Project
BARANGAROO STAGE 1B
PUBLIC DOMAIN
Modification S4.55

Drawing Title
HICKSON PARK SOUTH
ENTRY DETAIL PLAN - NO
TREES
Drawn
SS

Drawing Number
BAR-418-DA-HP-DP04
Checked
MW

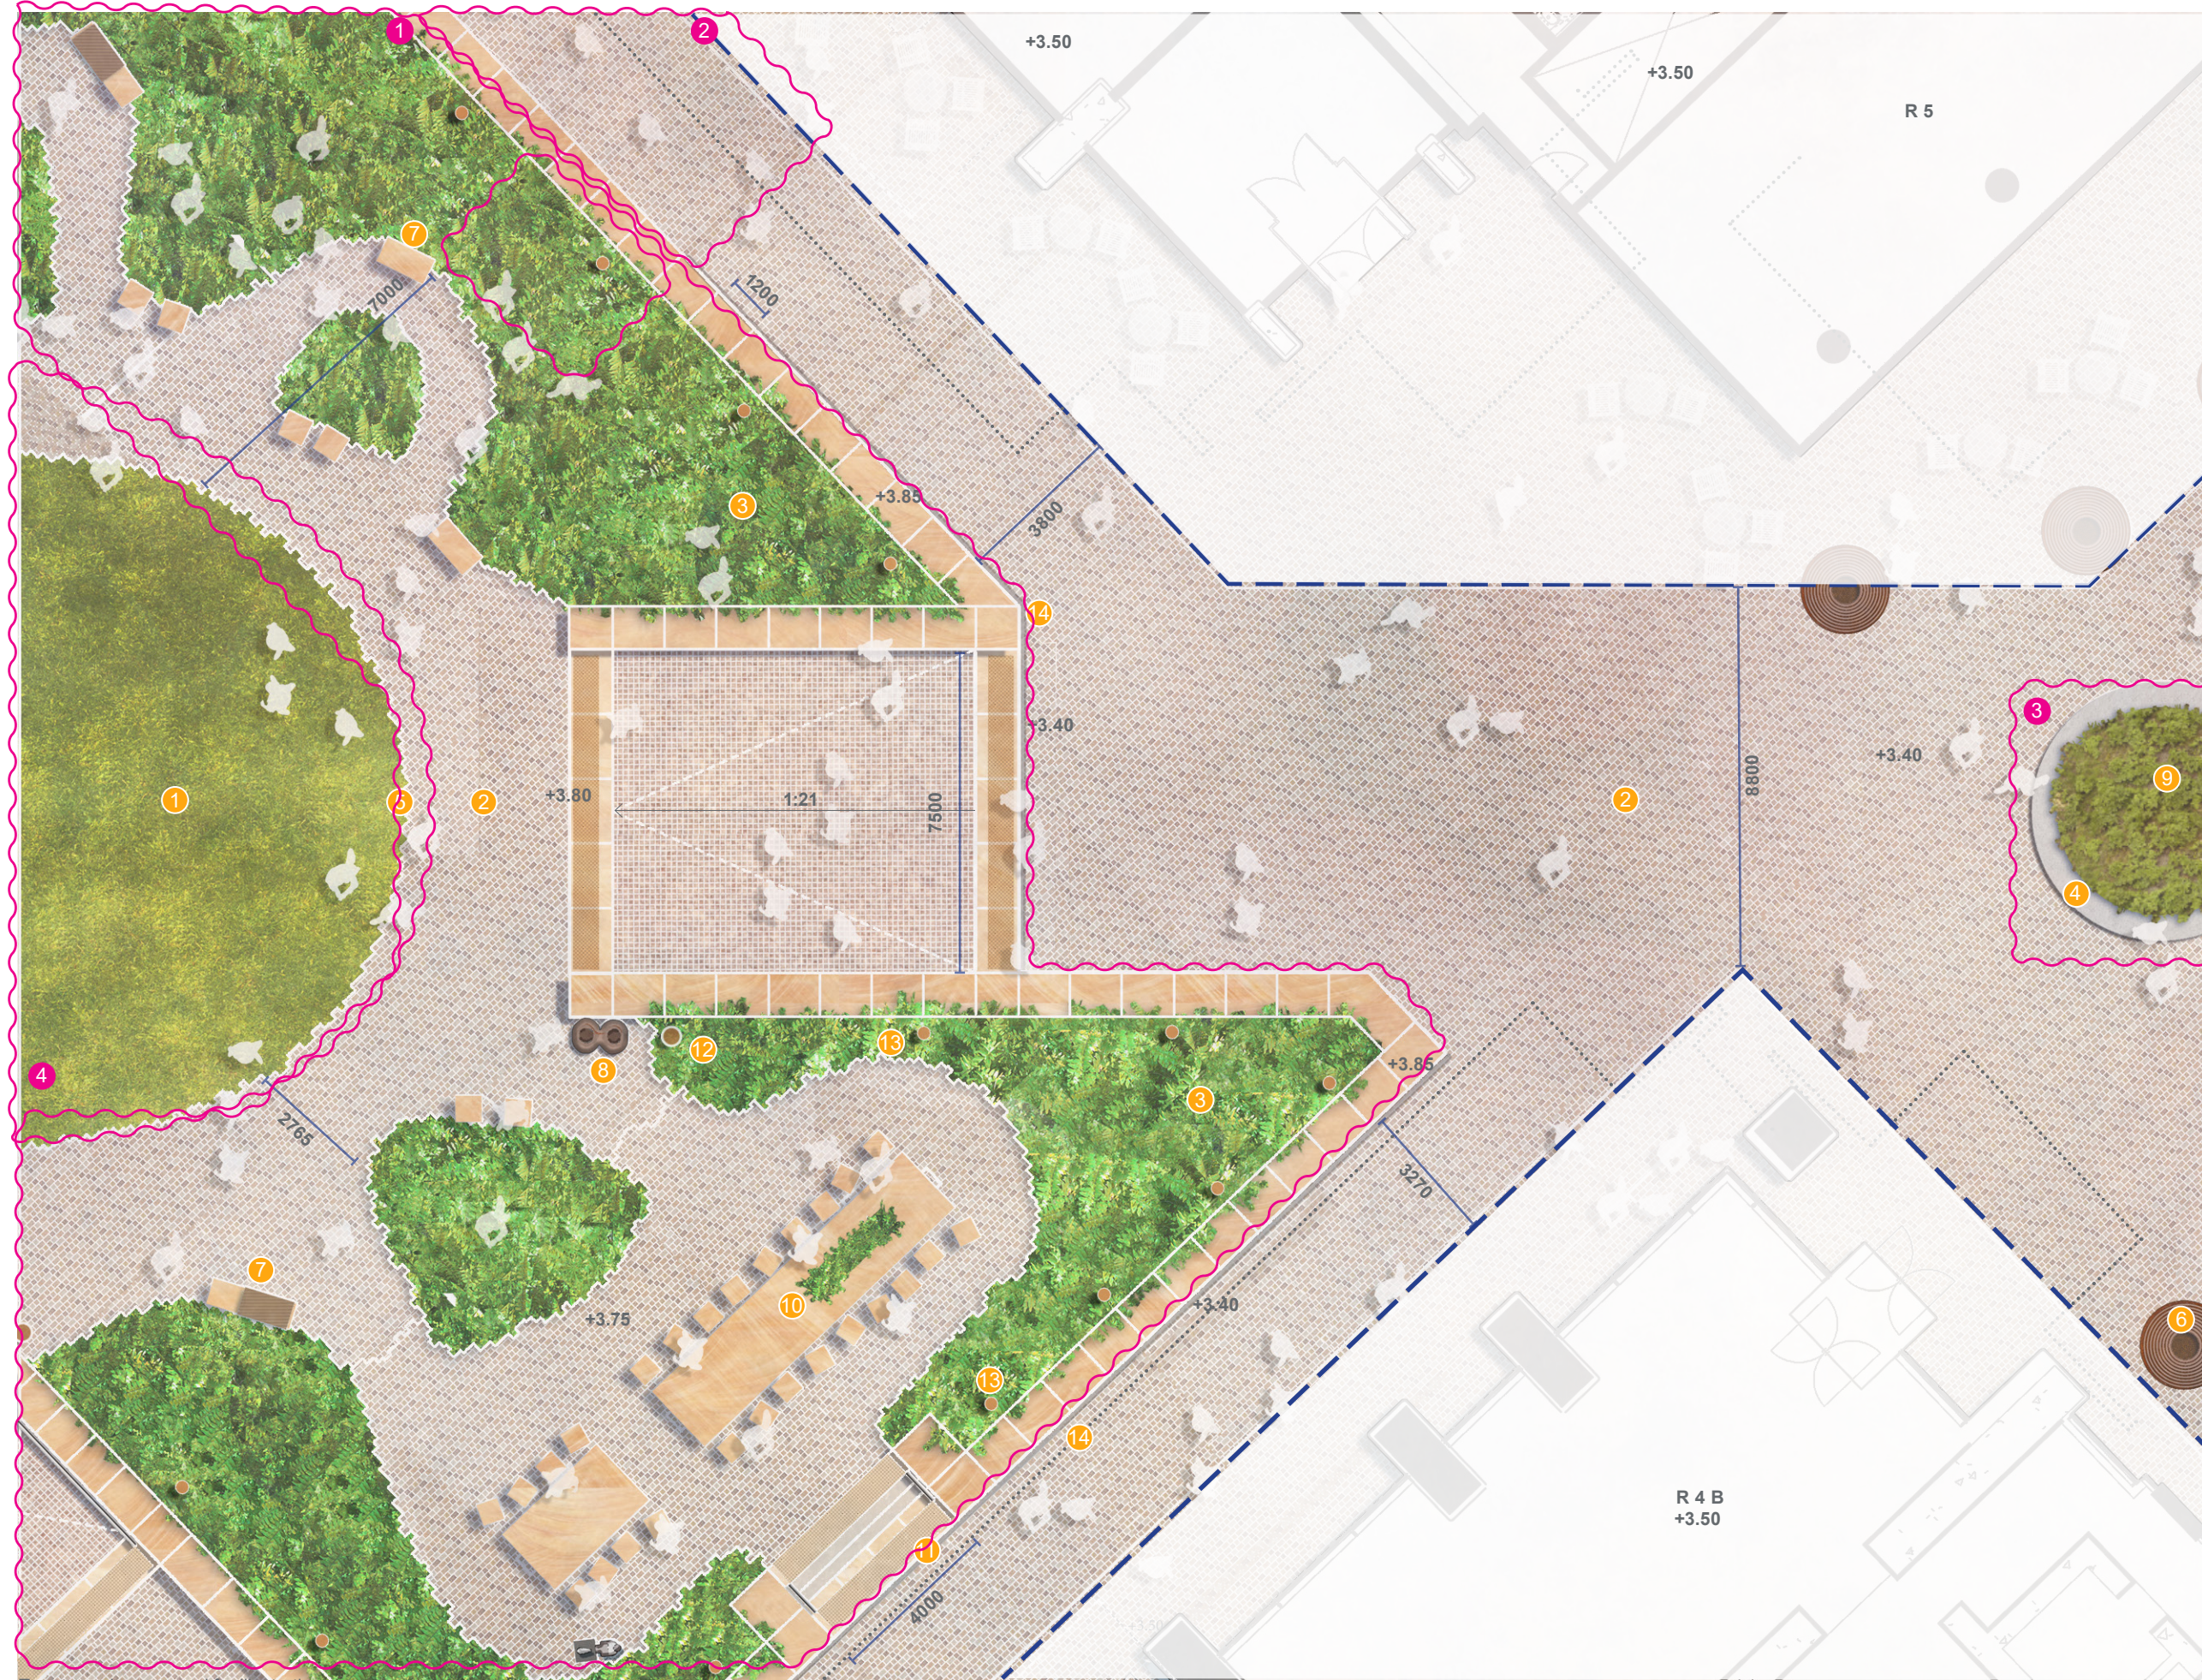
- 1 Increase planting area within the park, change of geometry and move 1no. access stairs.
- 2 Remove ramp and sandstone wall due to proposed Hickson Road levels
- 3 Remove timber top for Watermans Quay raised planter seating
- 4 Levels changed due to proposed Hickson Road levels

Drawing Title
**HICKSON PARK WEST ENTRY
DETAIL PLAN - NO TREES**

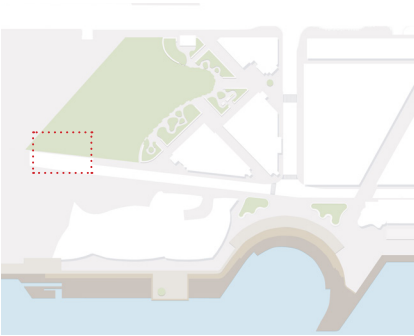
- Amendment cloud
- 1 Increase planting area within the park, change of geometry and remove 1no. access stairs.
- 2 Remove porphyry paving to City of Sydney transition as per consent requirement B23
- 3 Sandstone paving strip changed to City of Sydney paving along Hickson Park
- 4 Sandstone bollards changed to concrete
- 5 Additional smart pole

Drawing Title
**HICKSON PARK BOLLARD
STRATEGY**

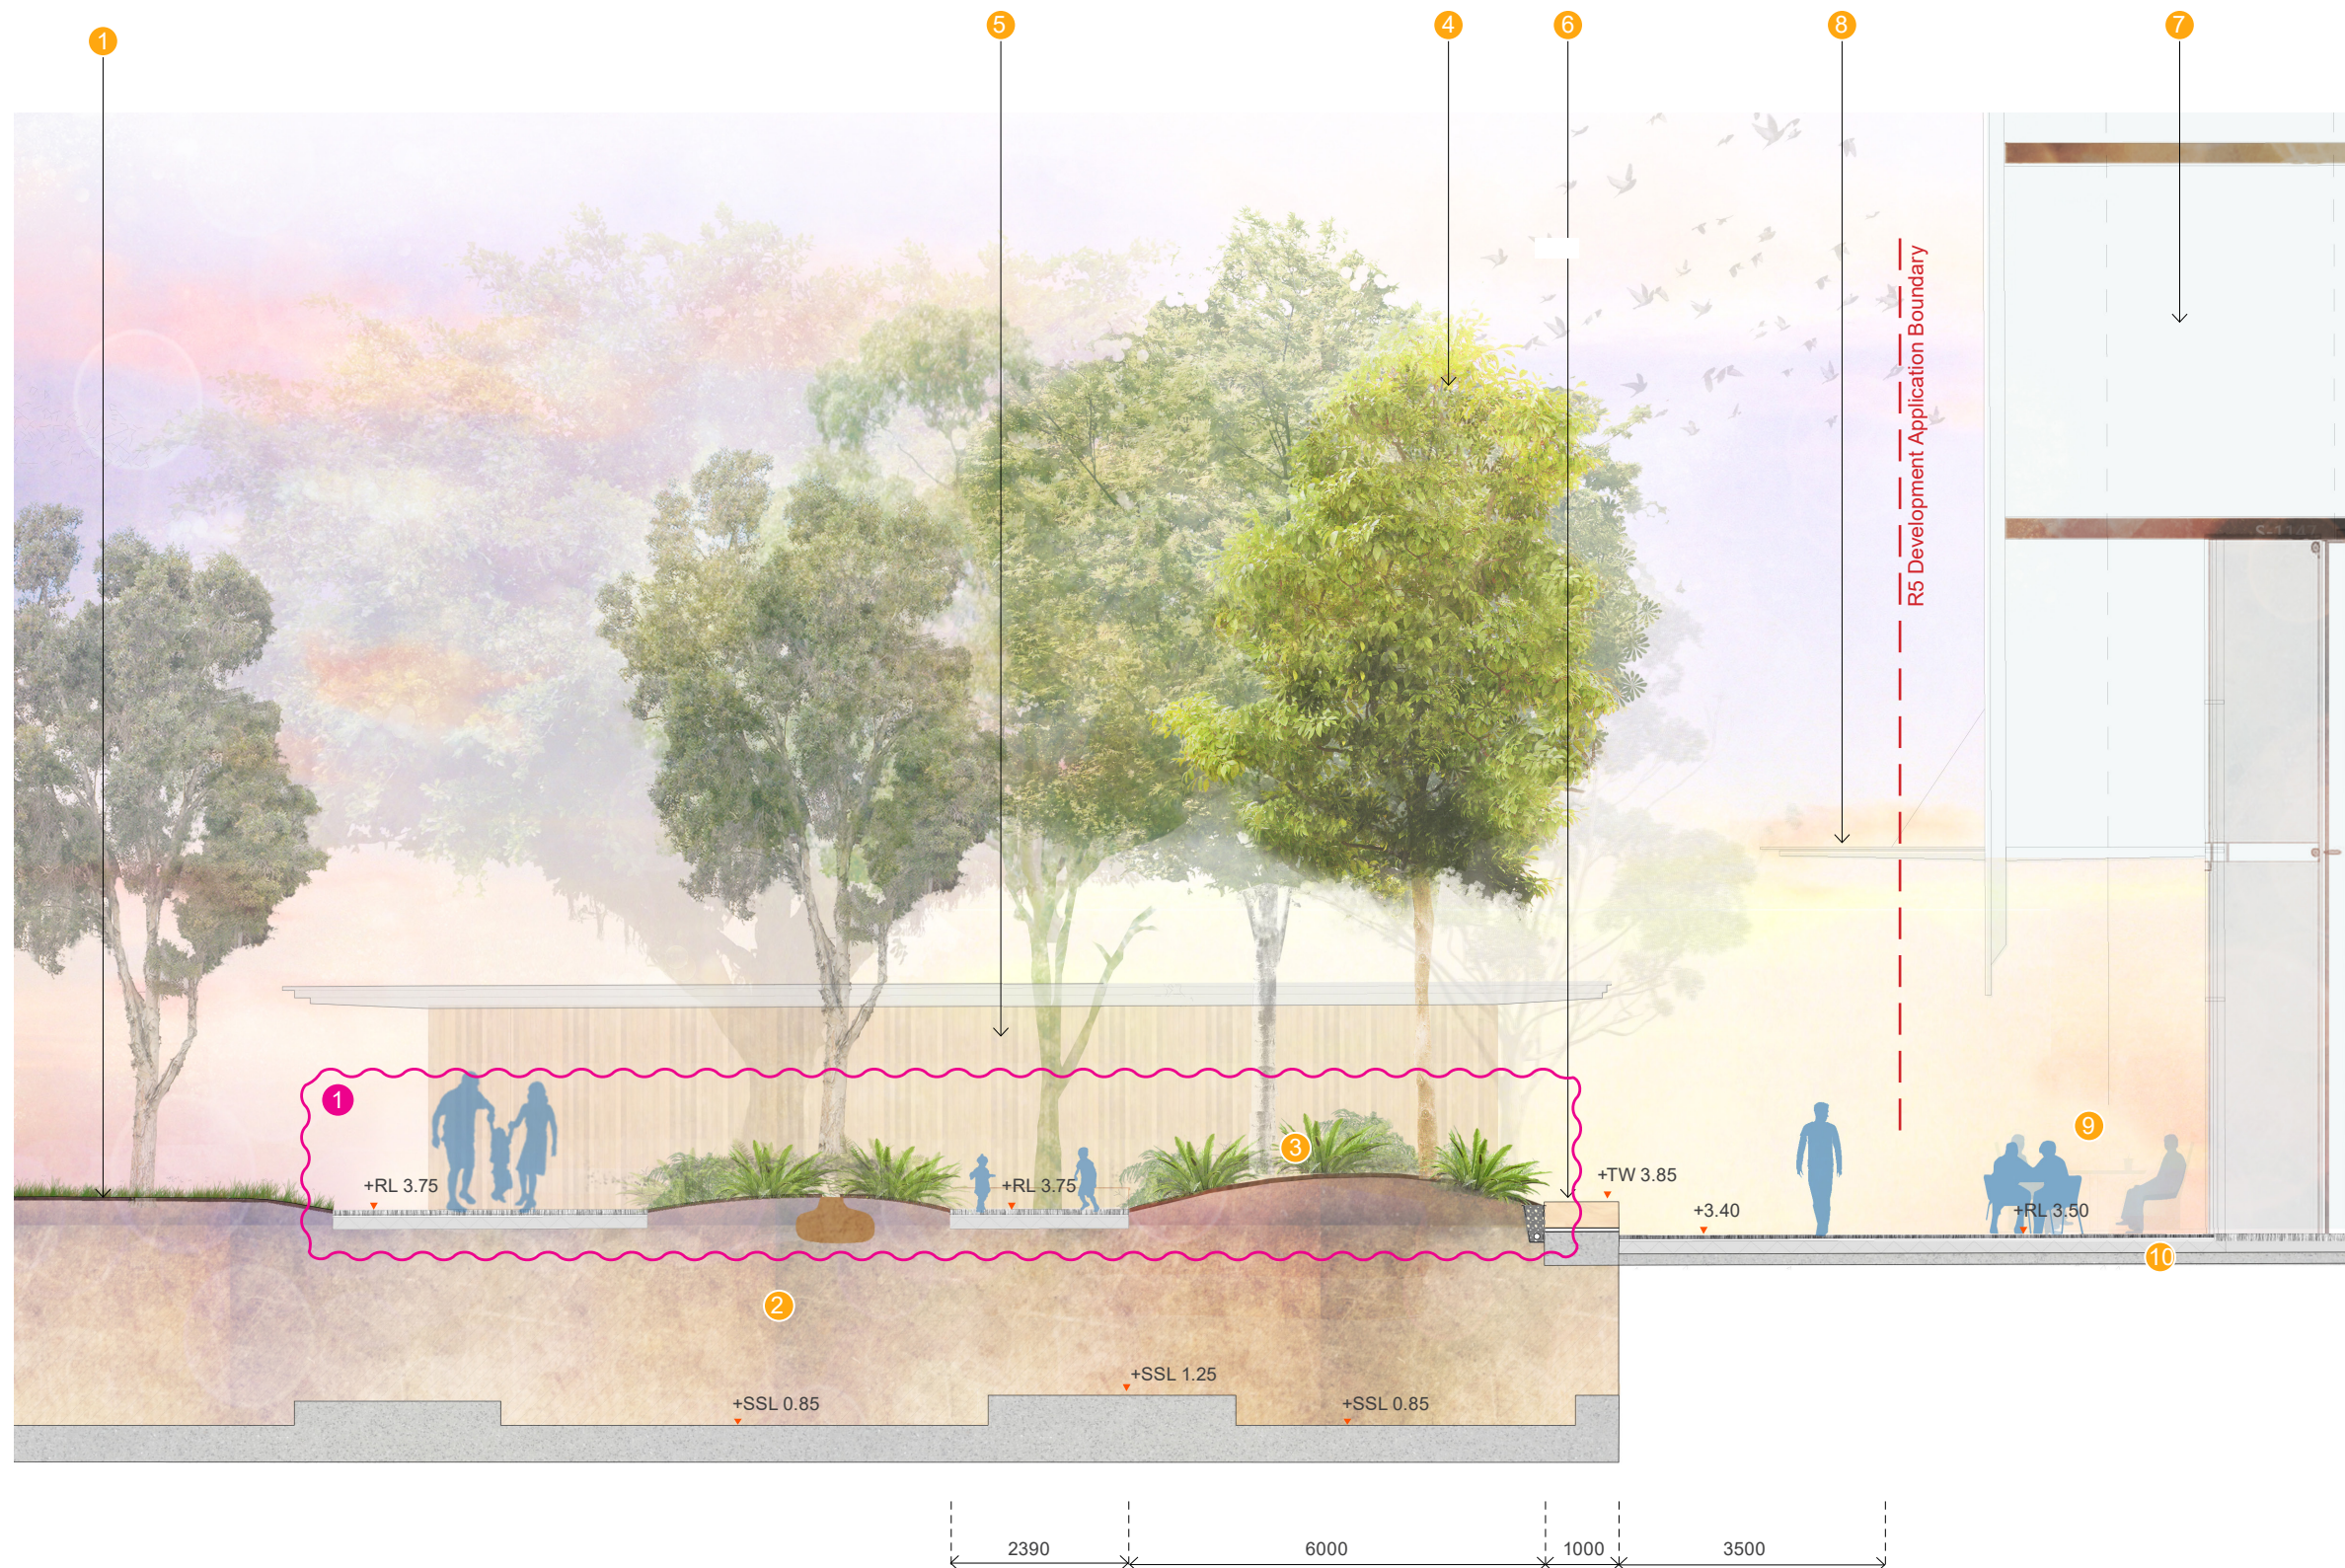
- 1 Sandstone paving strip changed to City of Sydney paving along Hickson Park
- 2 Sandstone bollards changed to concrete
- 3 Additional smart pole

Drawing Title
HICKSON PARK SECTION
I-I
Drawn
SS

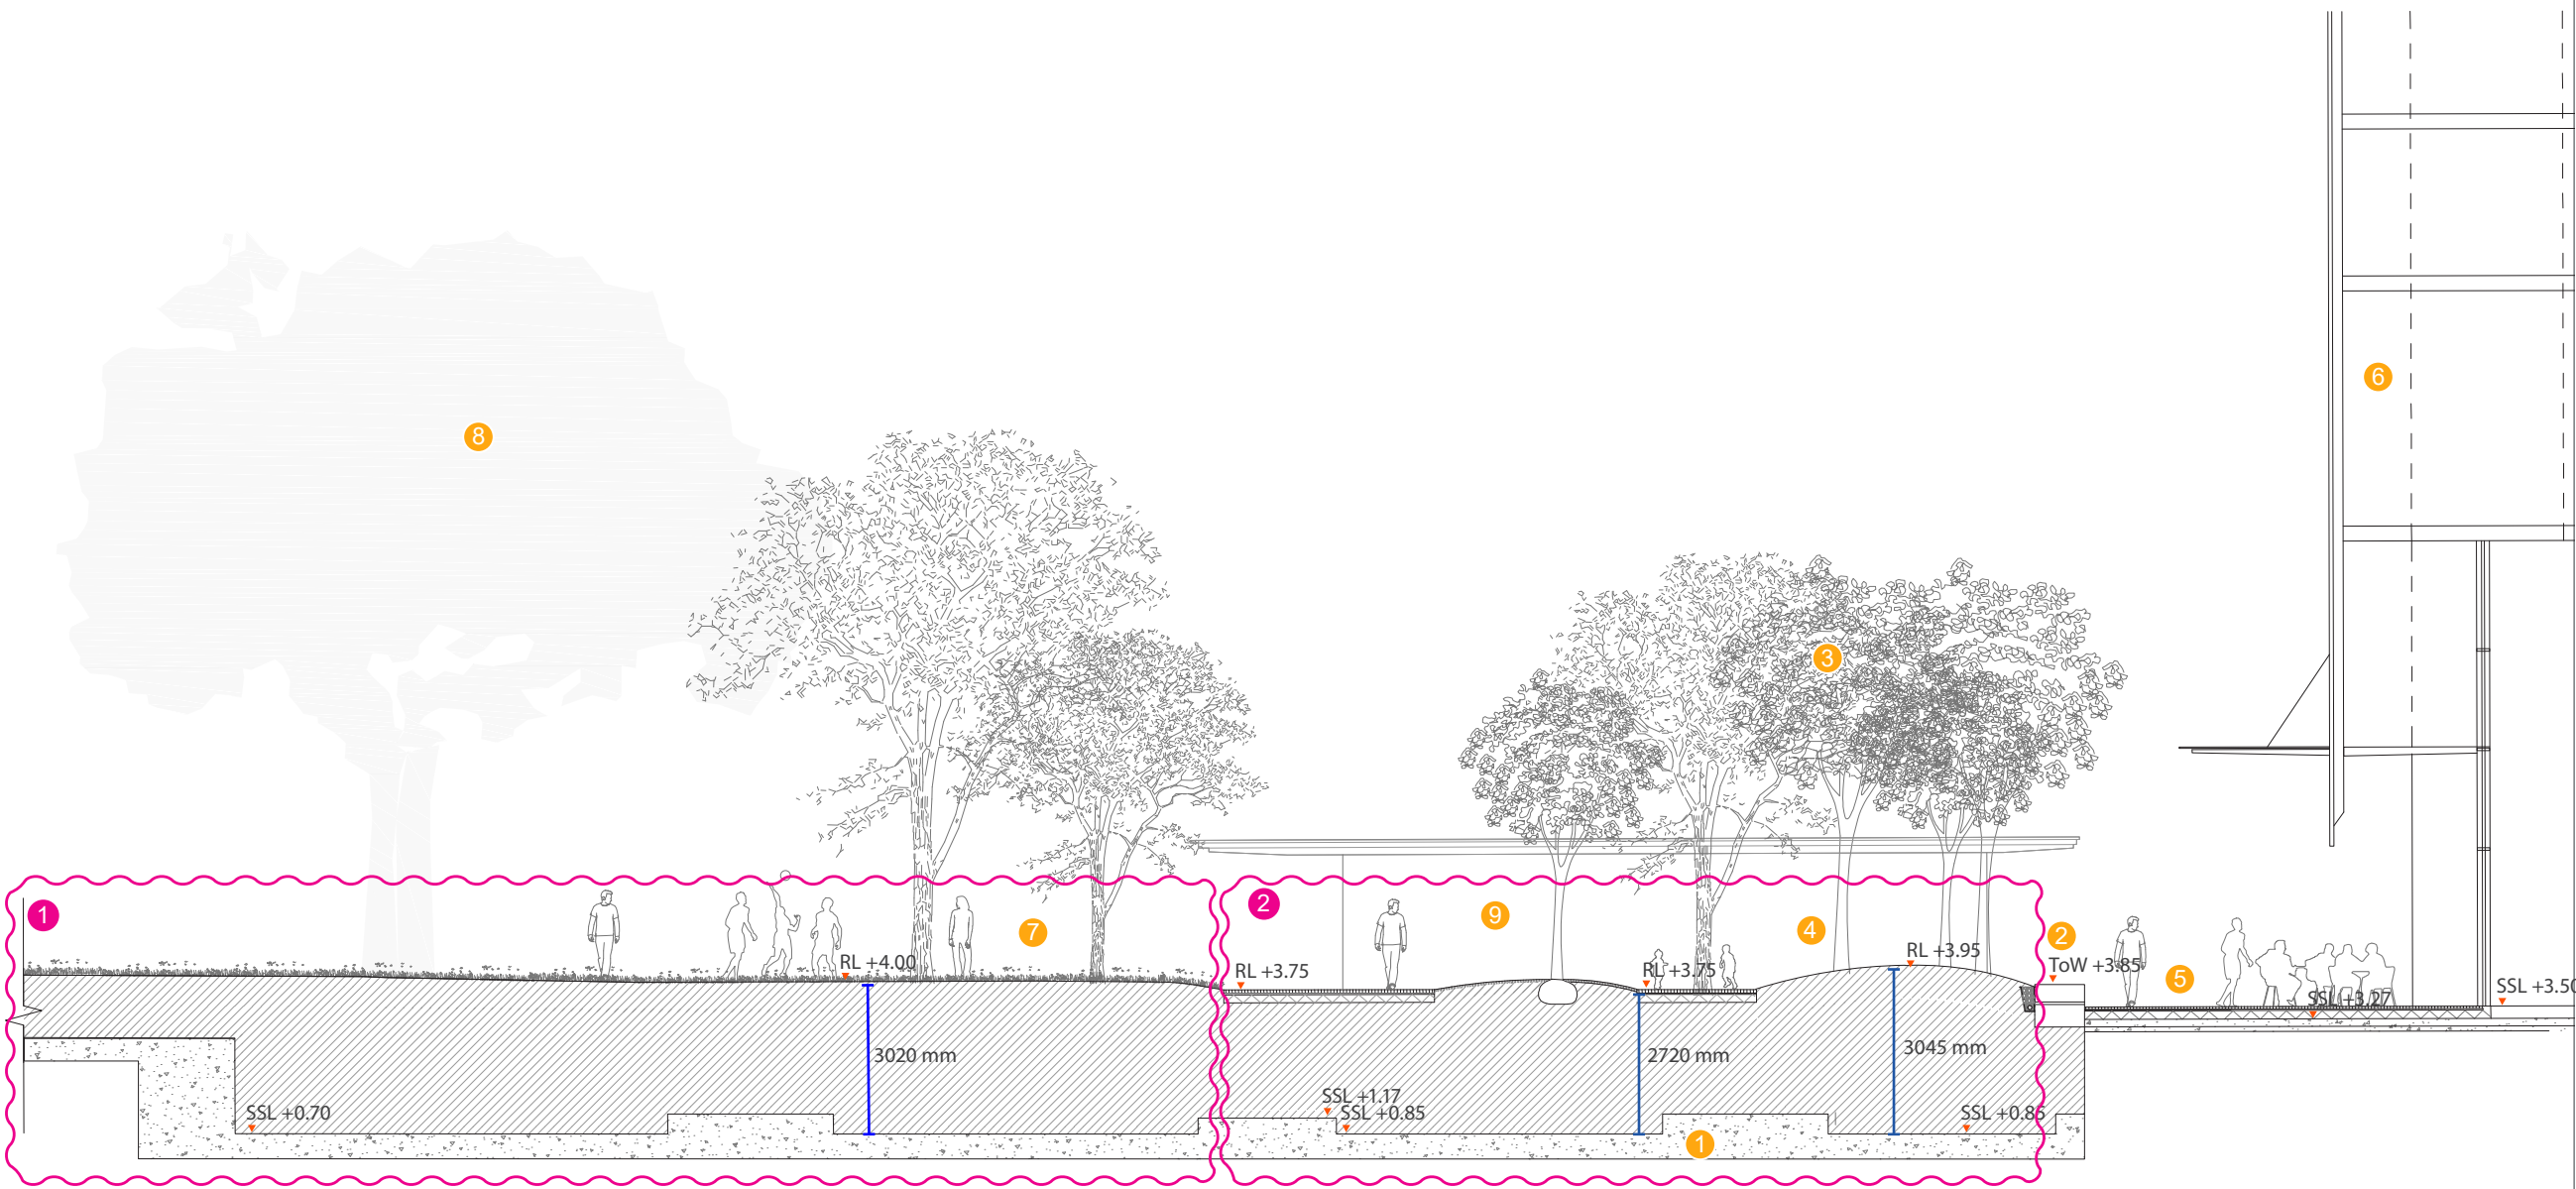
- 1 Levels changed due to proposed Hickson Road levels
- 2 Increase planting area within the park and change of geometry.
